City of Cody Planning, Zoning and Adjustment Board

**City of Cody**  
**Planning, Zoning and Adjustment Board Proceedings**  
**August 6, 2026**

### **Commercial Sign Review for Noir at 1544 Salsbury Avenue and Approval of Resolution PZ 26-33**

### **Downtown Architectural Review for Swelk, LLC at 1314 Sheridan Avenue and Approval of Resolution PZ 26-34**

SHEET #  
A2.1

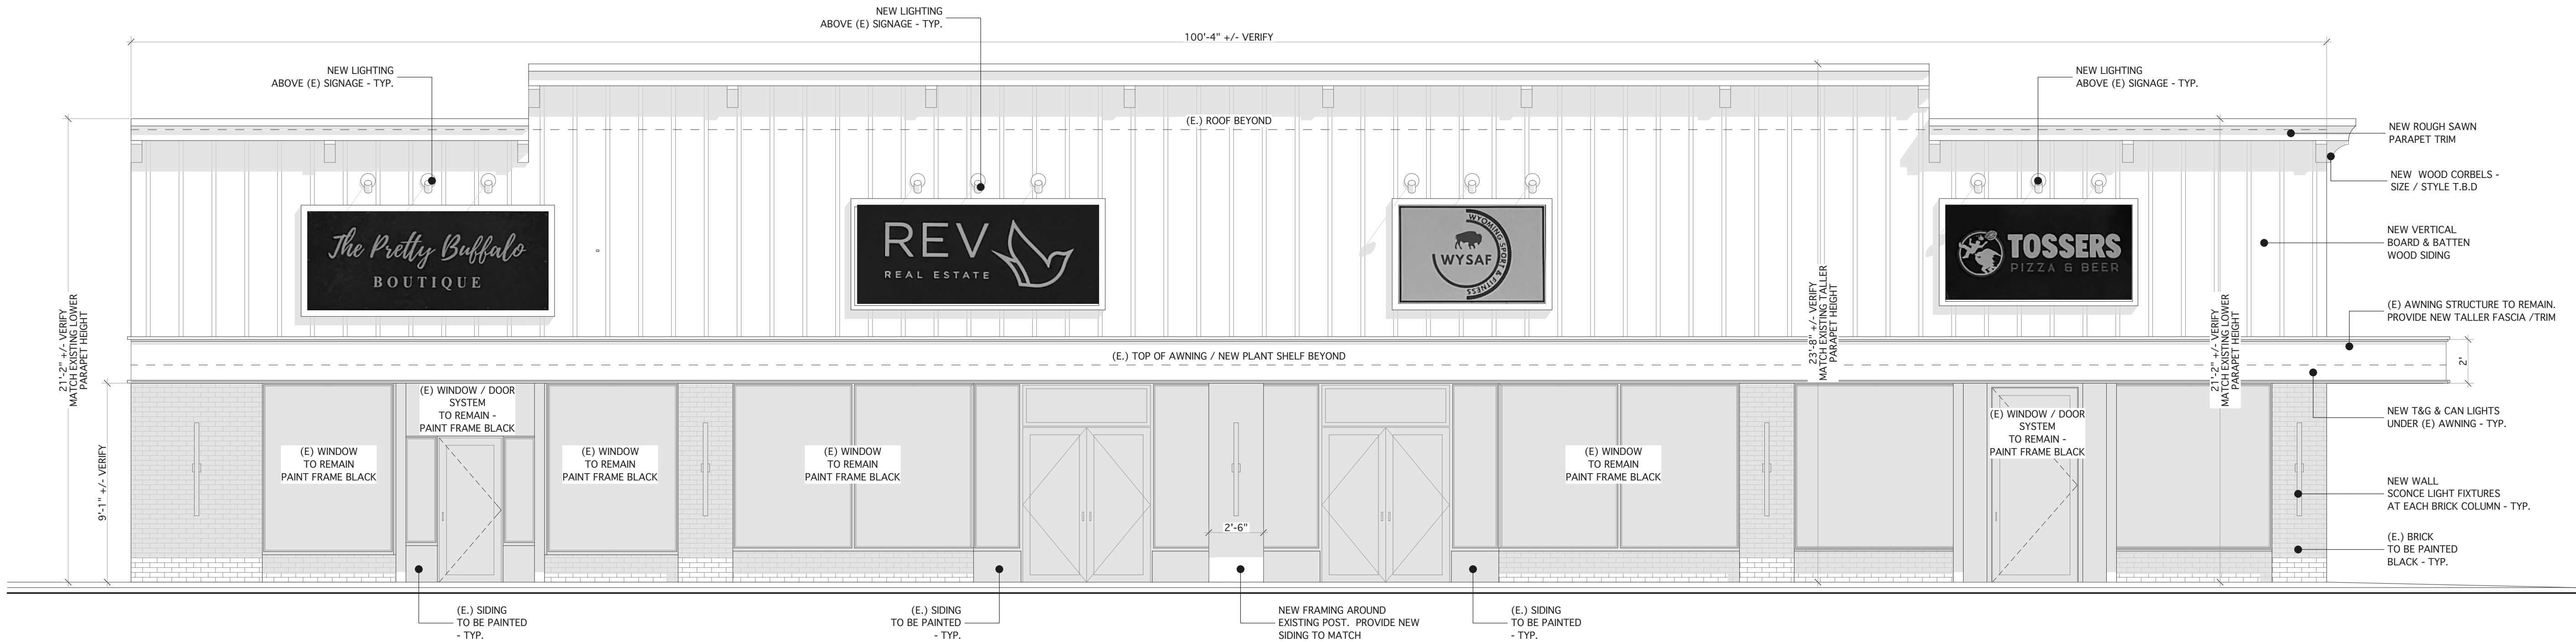
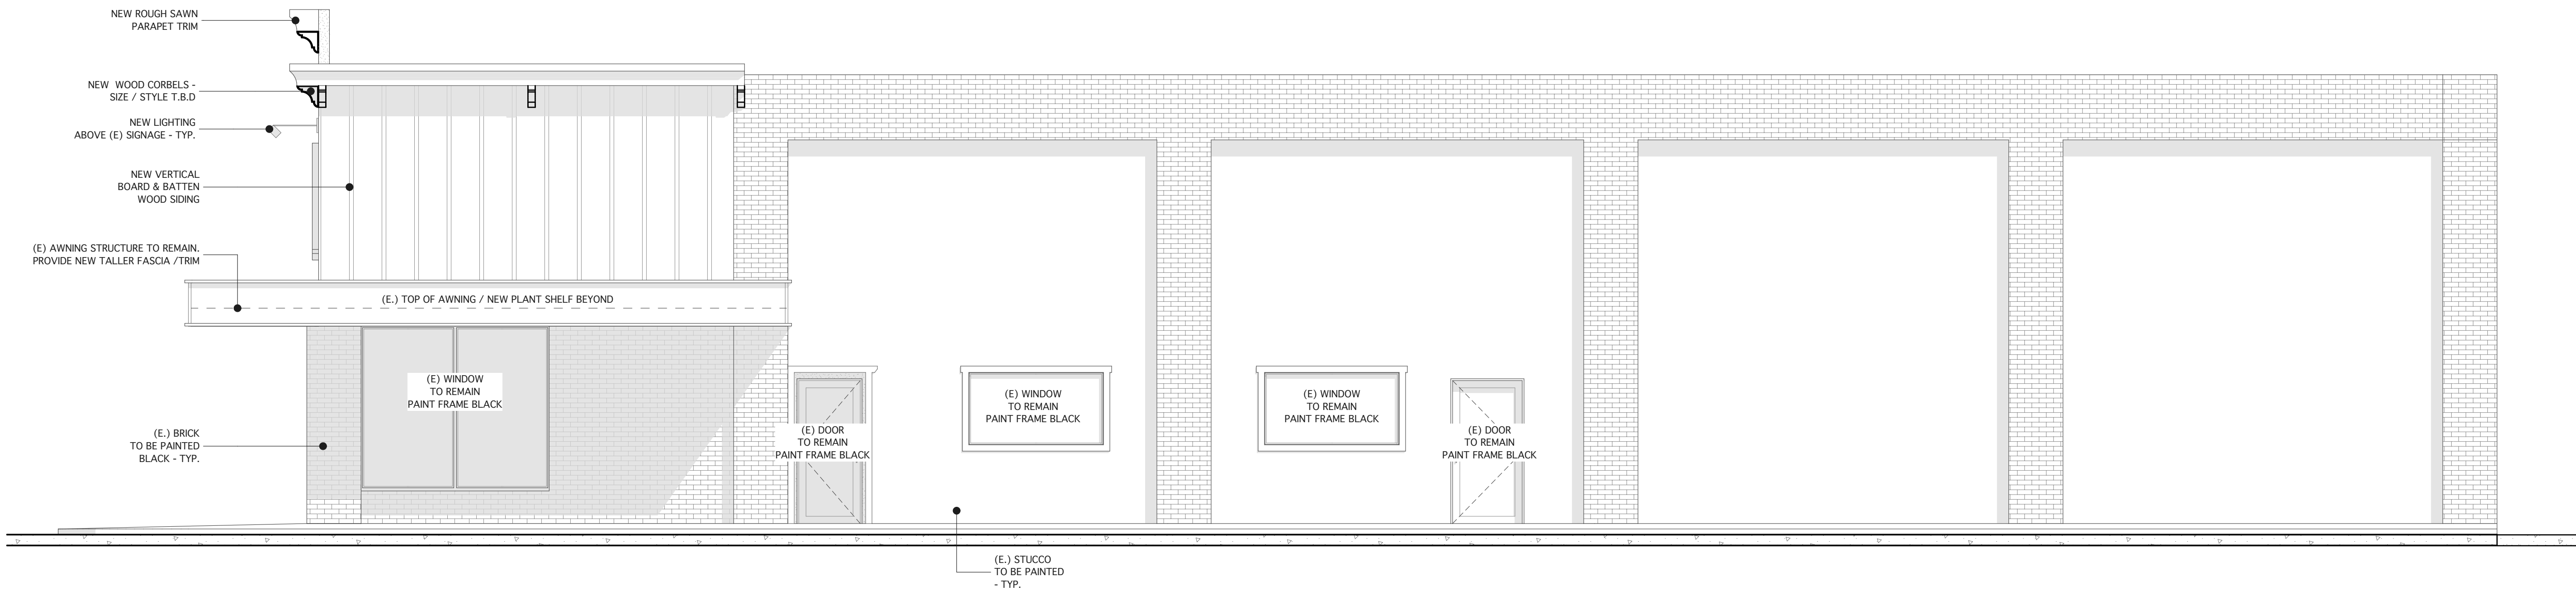
Staff Comment: The proposal will replace the existing exterior of the storefront with a brick and wood façade as shown in the rendition above. The signage and sign lighting will be reviewed separately, as the applicant is still working on those plans.

Staff has no concerns with the proposed architectural changes. The colors and architecture proposed is a substantial upgrade to this downtown building.

Staff Comment: The entire building frontage will be comprised of brick and wood, meeting this standard.

1. Signage review is required by the City prior to installing new signage and exterior sign lighting.
2. The applicant will obtain all necessary building permits from the City, prior to commencing work.

| DATE    | DRAWING LOG      | BY   | CHECKED | APPROVED | DRAWN BY: IKSM     |  ENGINEERING ASSOCIATES – CODY, WYOMING<br>CONSULTING ENGINEERS & SURVEYORS | OWNER:                 | PROJECT: | C STREET LOTS 5 & 6 | C3.0 |

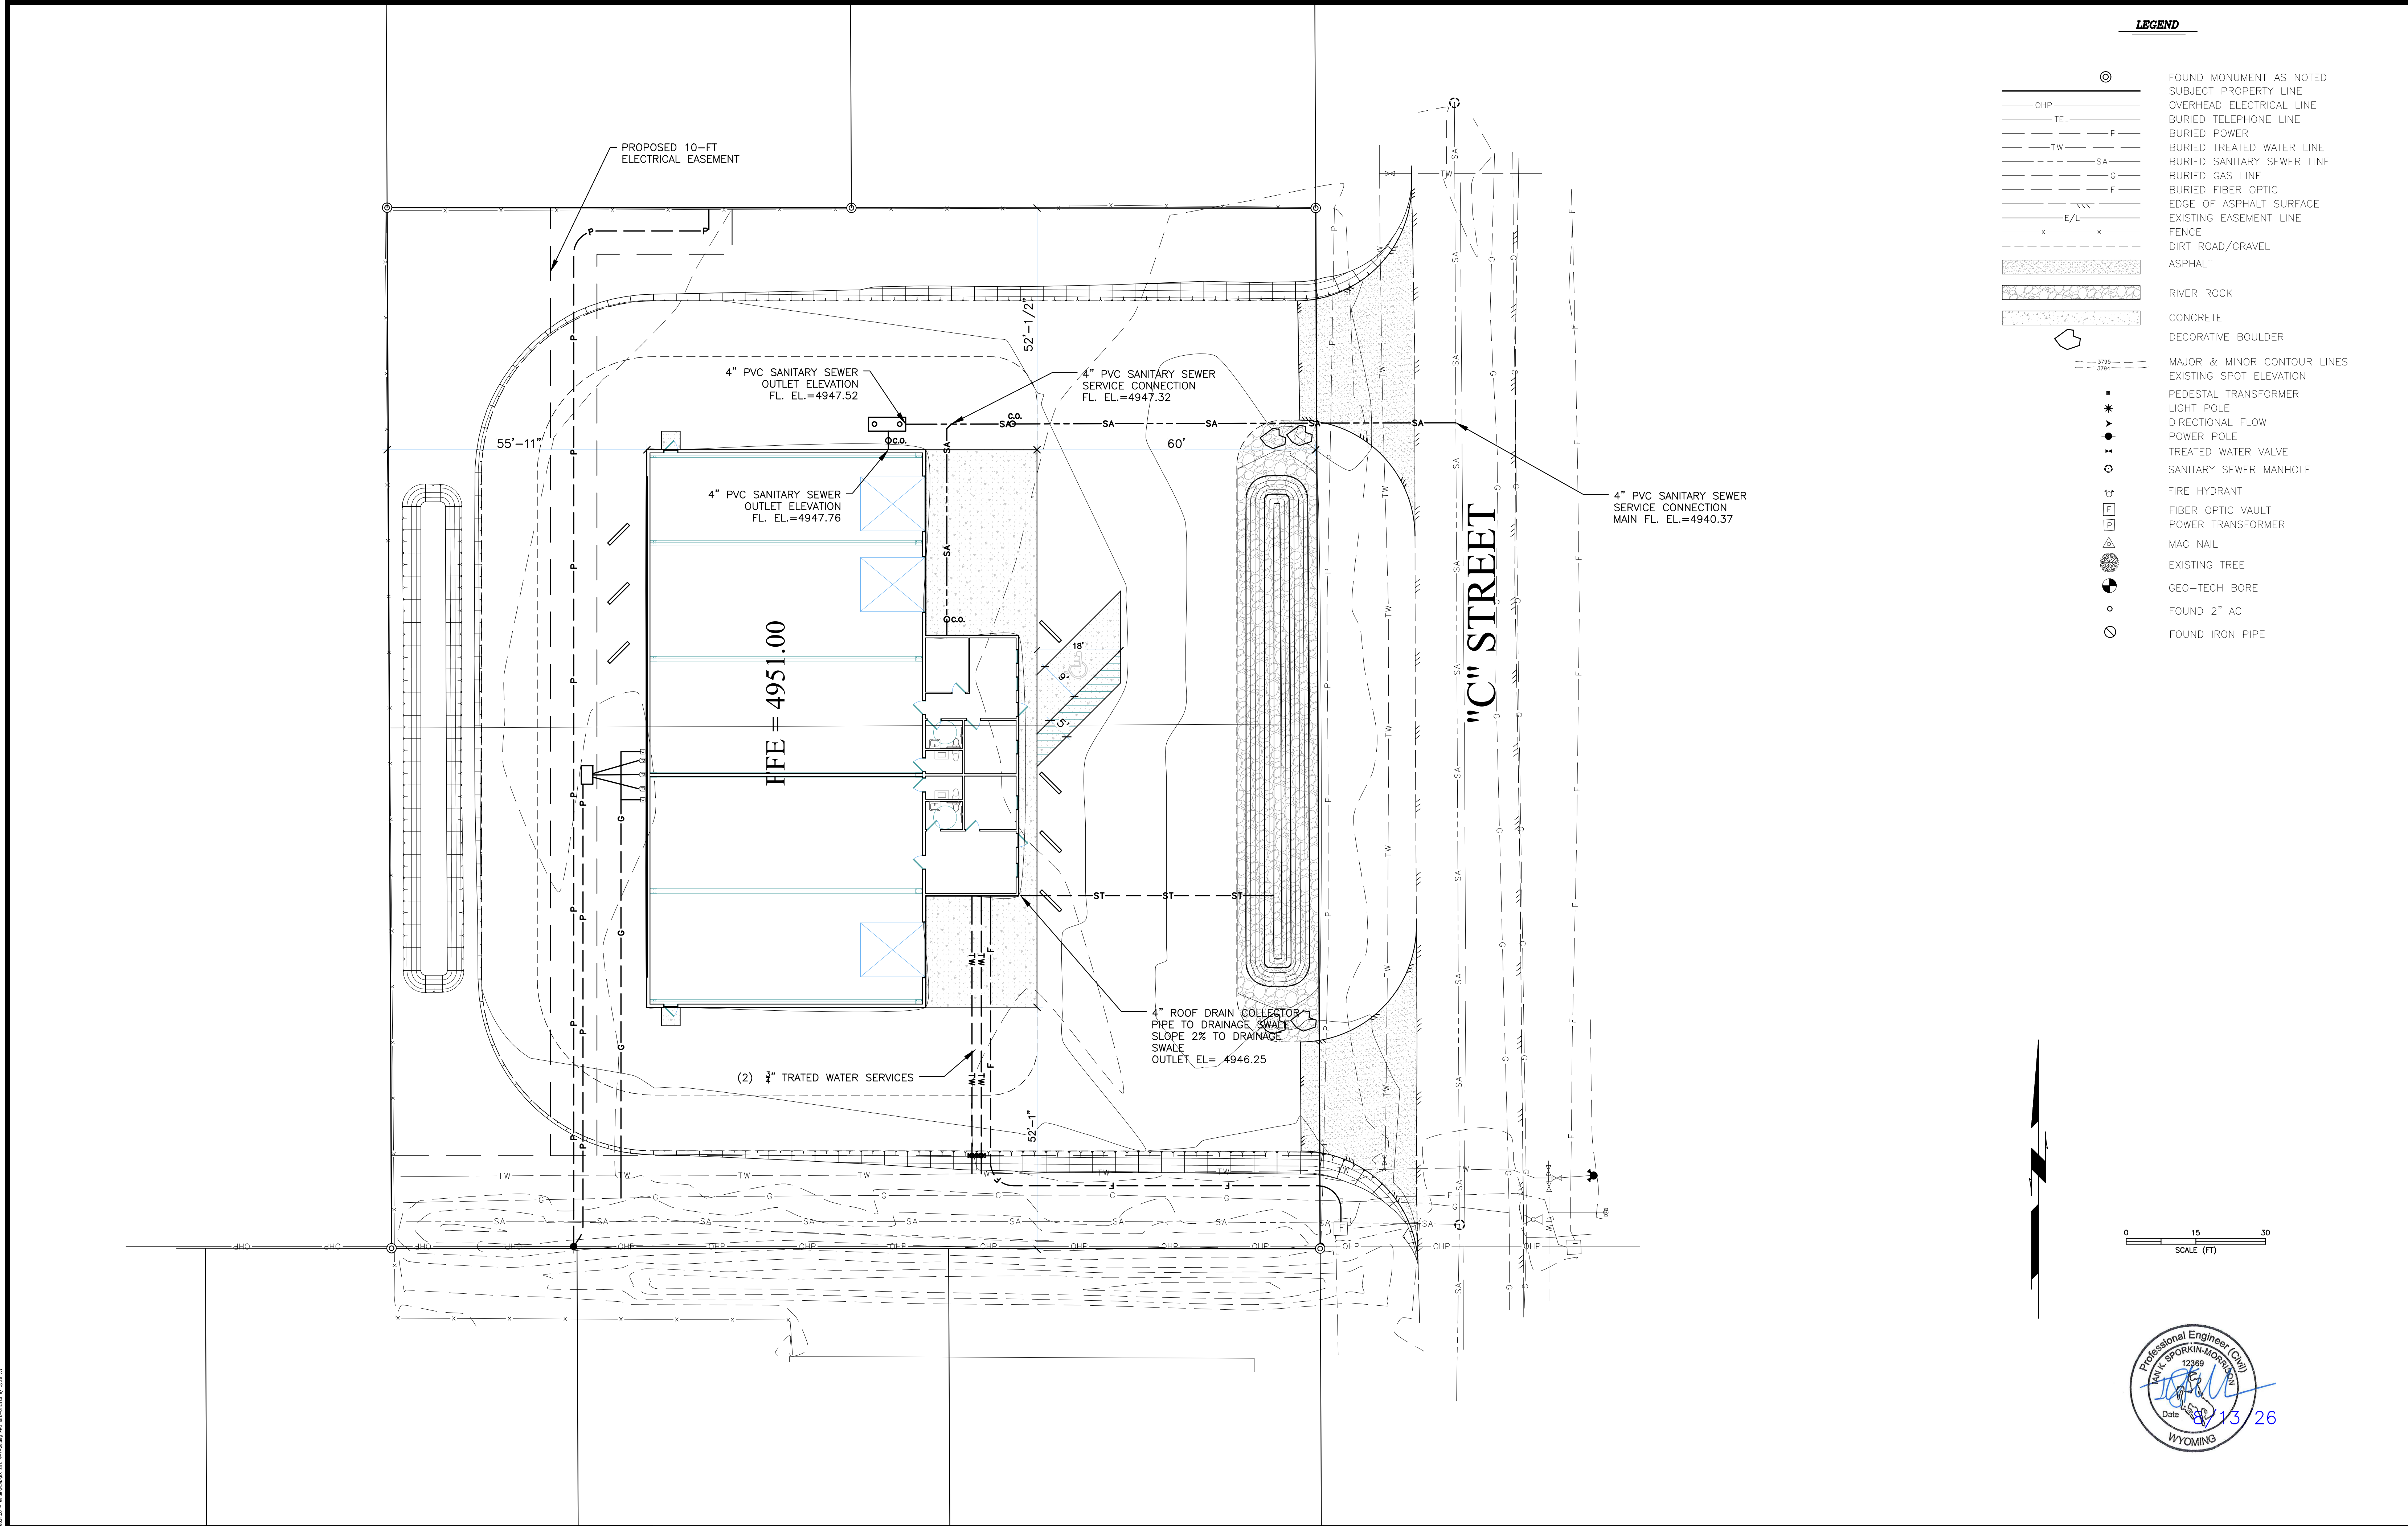
relocated to the west side. The applicant is working with the City regarding easement and the details of the relocation. Power will be brought to the new structure from the west side as shown on Sheet C3.0.

The building will have two individual ¾" treated water and a 4" sewer service connections as shown on Sheet C3.0.

The Public Works Department is reviewing the utility plans and final approval will be required by the department prior to issuance of a building permit.

KT-WPLEDXX-M2-XX VDIM  
ARCHITECTURAL FULL CUTT OFF LED WALL PACK

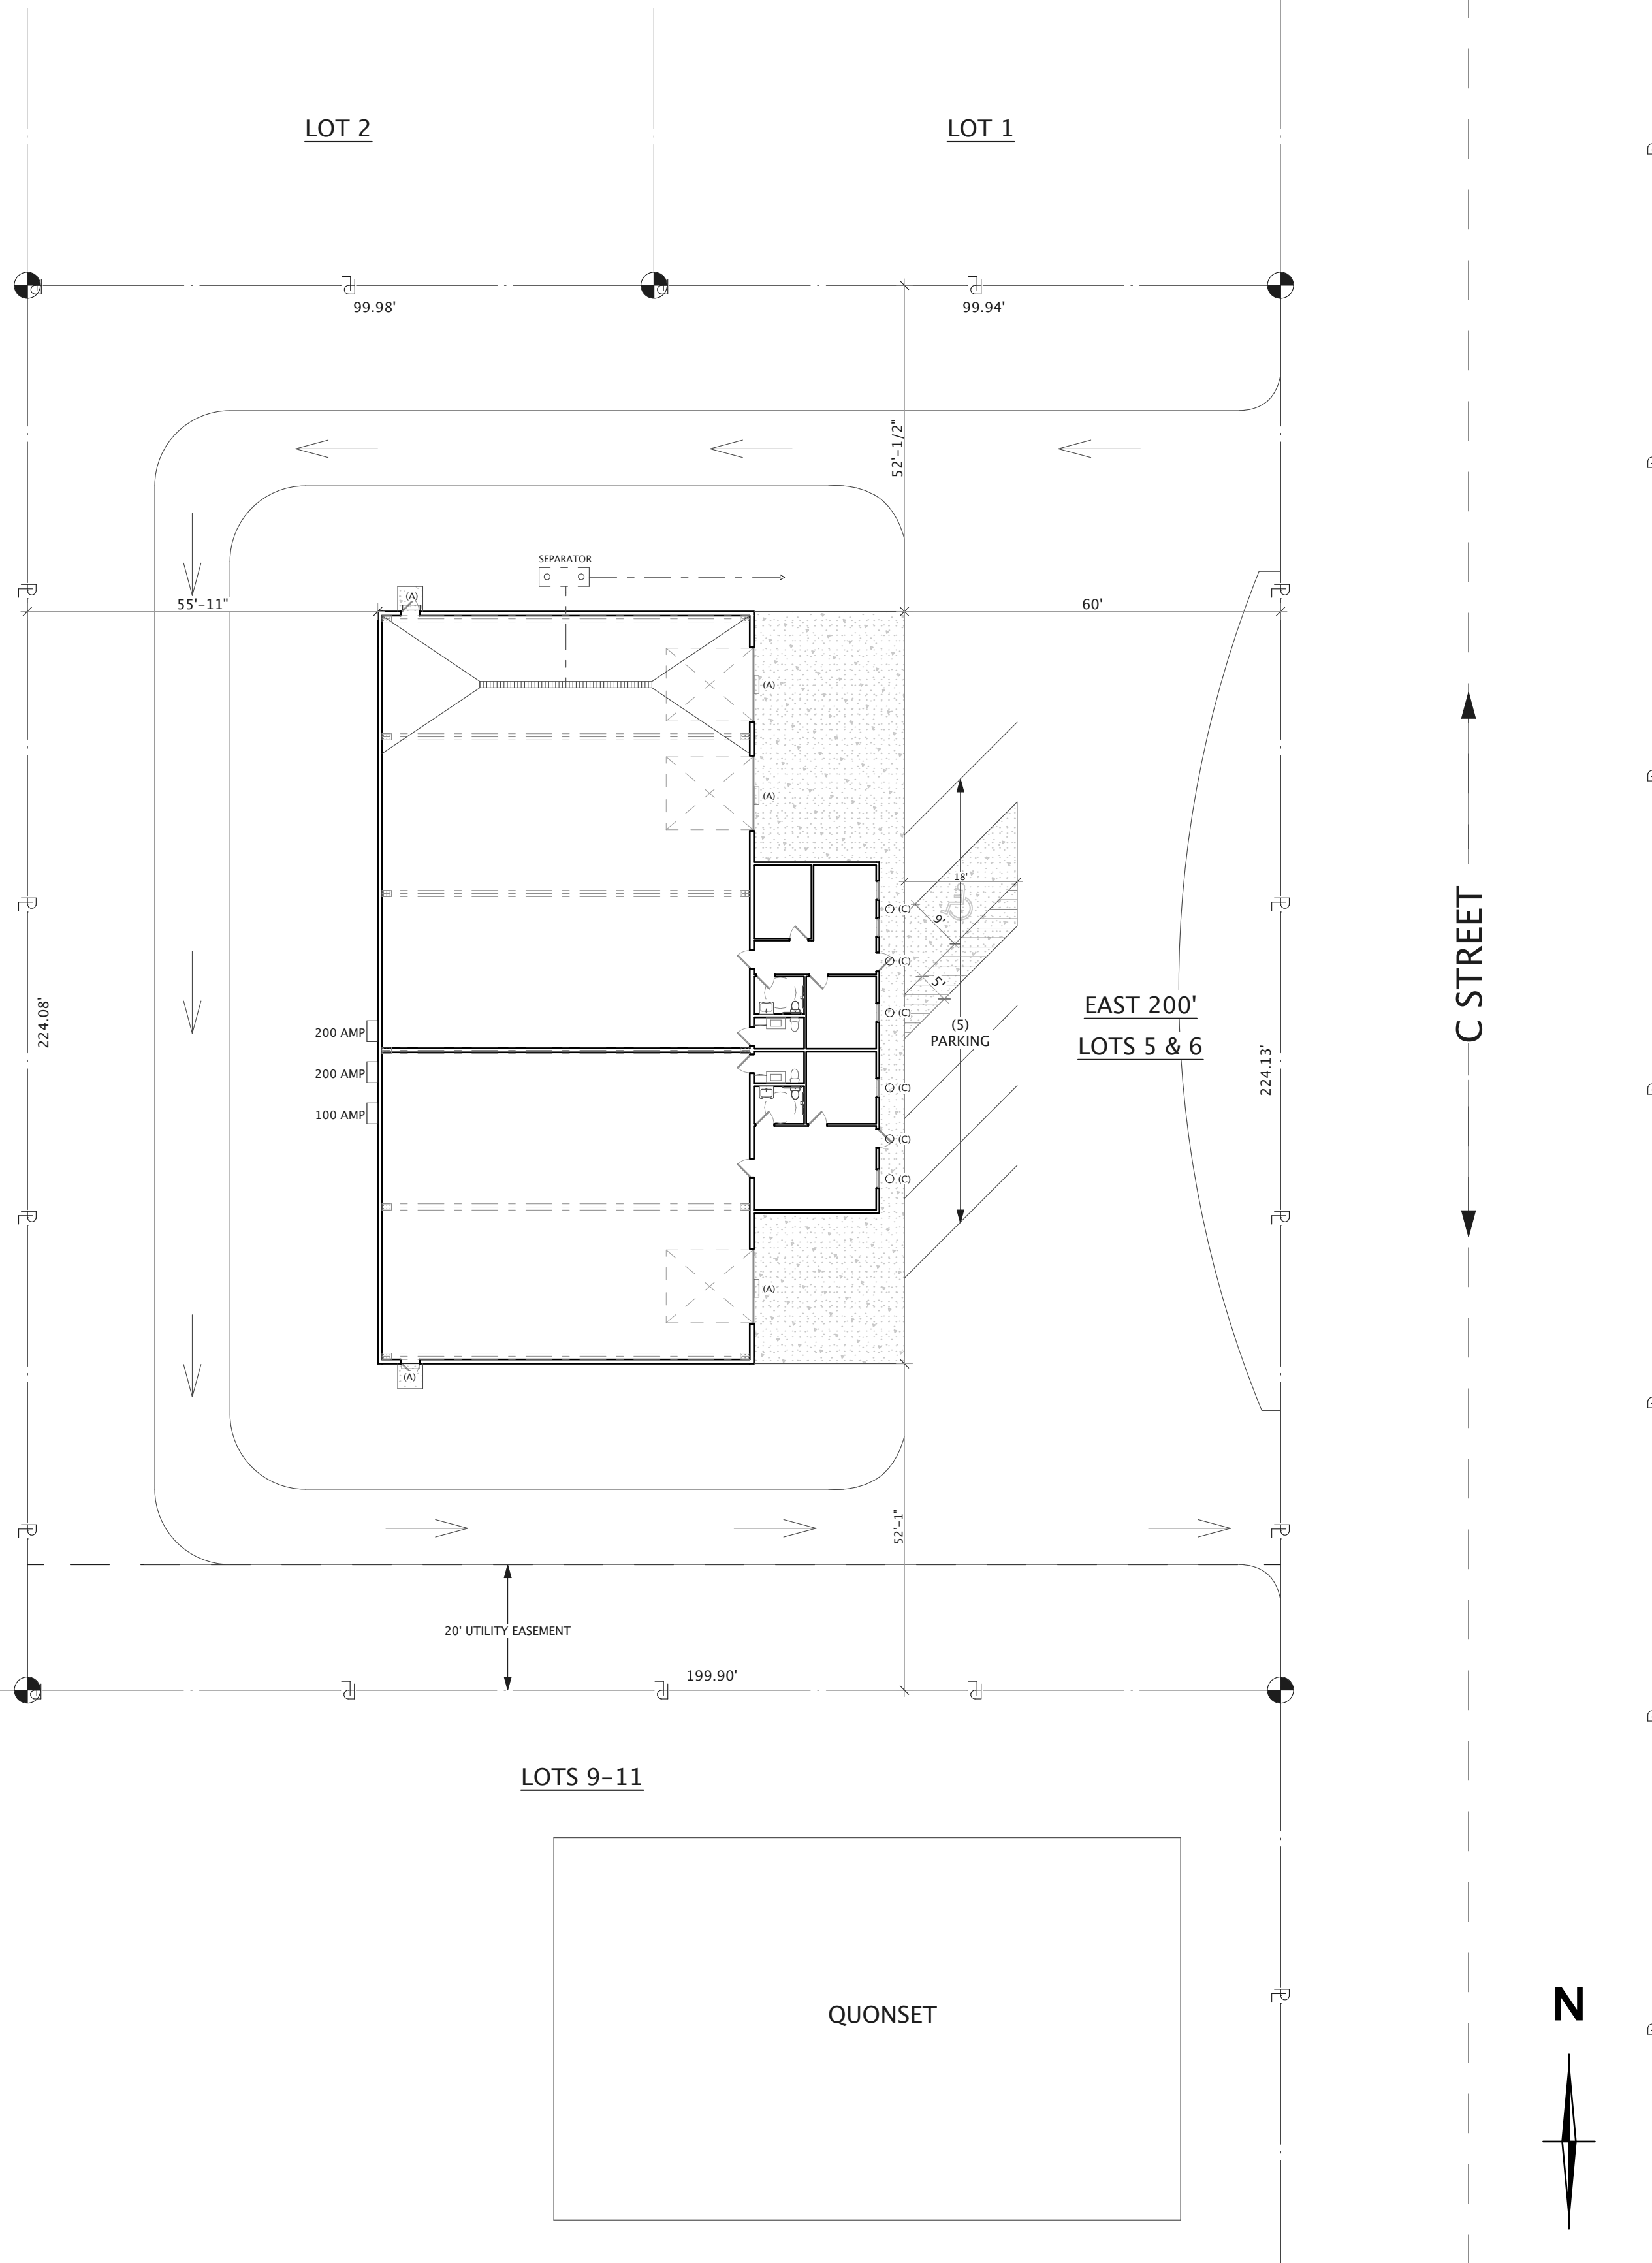
Exterior lighting locations are shown on sheet C1.0 of the site plan. The fixture is shown to the right. Specifications are provided and the lighting exceeds the current City lighting standards. The applicant is seeking an exception from City Council to allow the lighting because they feel it is required for safety of the building lessees and their customers or employees. The lights are full cutoff and down directed. A depiction of the fixture is shown to the right.

4. An approved lighting exception from City Council will be required before the proposed lighting is installed, or if the exception is denied by Council, the applicant shall provide a code compliant lighting plan to the planning department for staff review and approval prior to installation of lighting;
